# SERVICE BULLETIN

Classification: EC18-003	Reference: NTB18-016	Date: February 27, 2018
-----------------------------	-------------------------	----------------------------

## 2018 PATHFINDER; MIL ON WITH DTC P34A5, AND/OR P34A9 STORED

**APPLIED VEHICLES:** 2018 Pathfinder (R52)  
**APPLIED DATE:** Built before December 18<sup>th</sup>, 2017

# Electric Intake Valve Timing Control Module Location

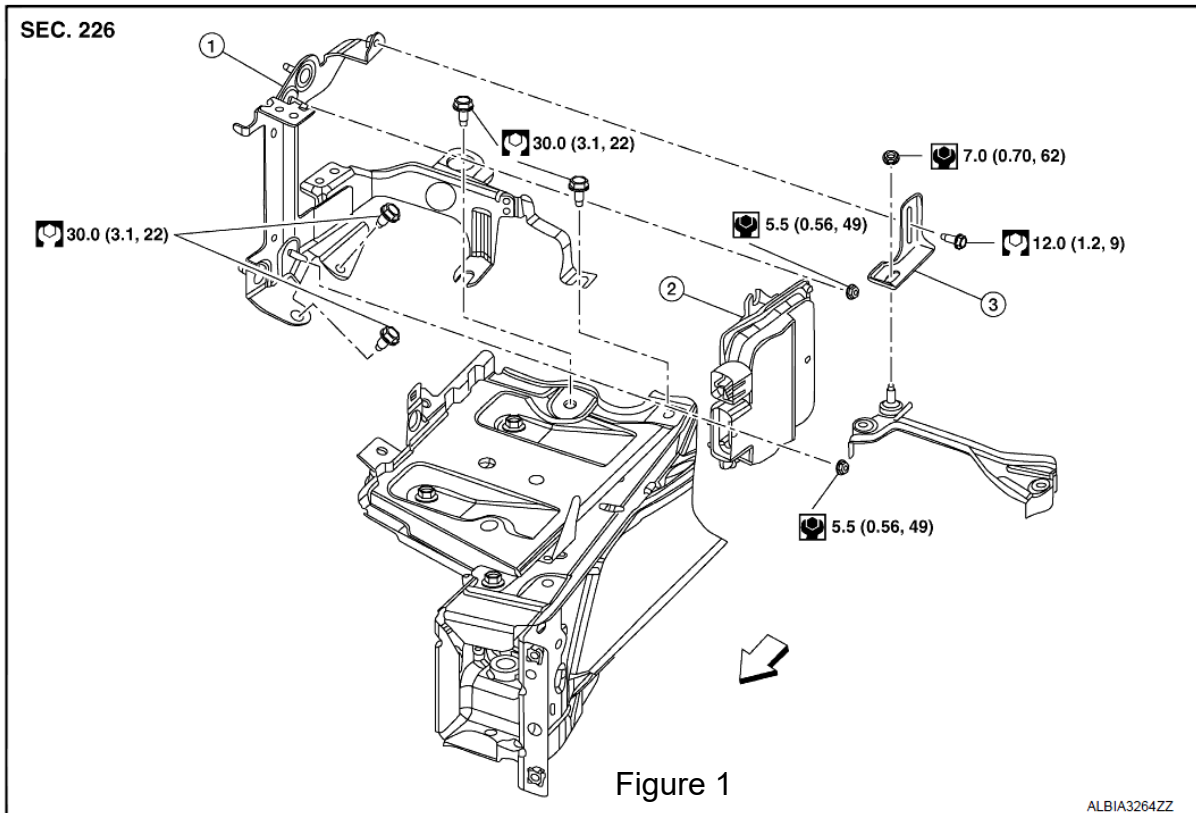
Replace the electric intake valve timing control module (see Figure 1 on Page 2).

- Electric intake valve timing control module is listed in the Parts Information of this bulletin.
- Refer to the Electronic Service Manual (ESM), section **ENGINE > ENGINE CONTROL SYSTEM**, for replacement information.
- Make sure to perform Electric IVT Control Actuator Position Learning after replacement of the module.

Figure 2

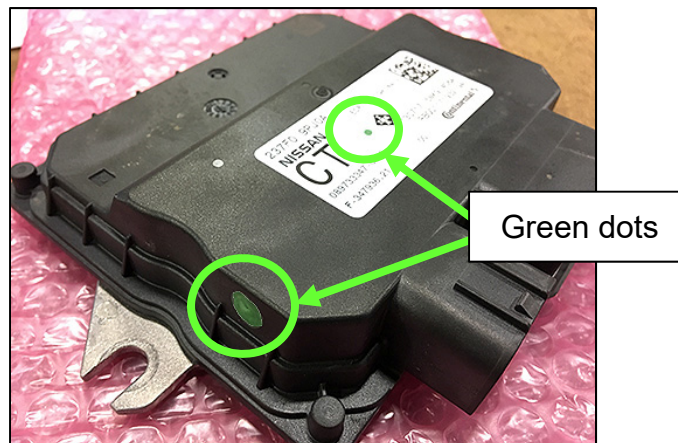
- (1) The new part must either have the green dots as shown in Figure 2 or an “AB” with additional “QR” on the label as shown in Figure 3, to indicate that it has the correct software version.
